Addendum No. 1

Date: July 11th, 2023

Project: Kelso
KHA Kalama Office Remodel
Kalama, WA

1.6 A3.0

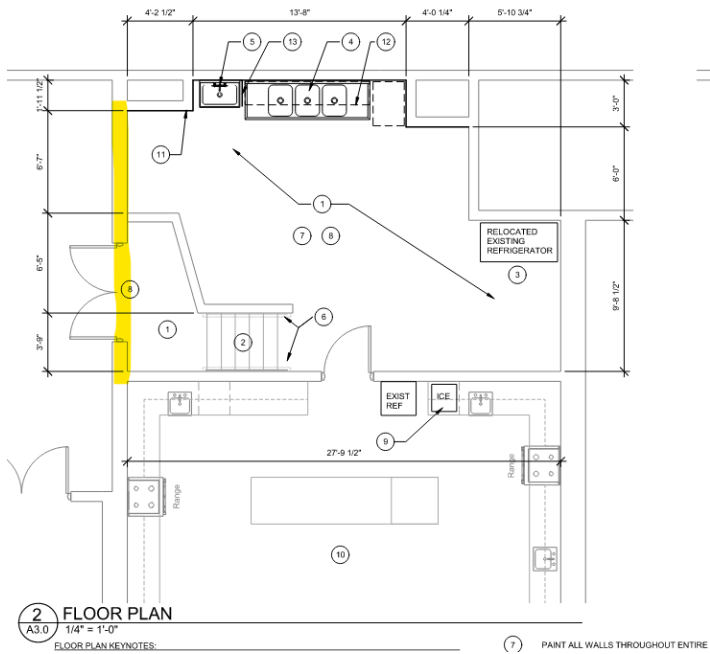
The wall highlighted in the image below is an existing painted brick wall. In addition to the manufacturer's surface prep recommendations, remove all loose paint and seal any existing cracks with paintable caulk.
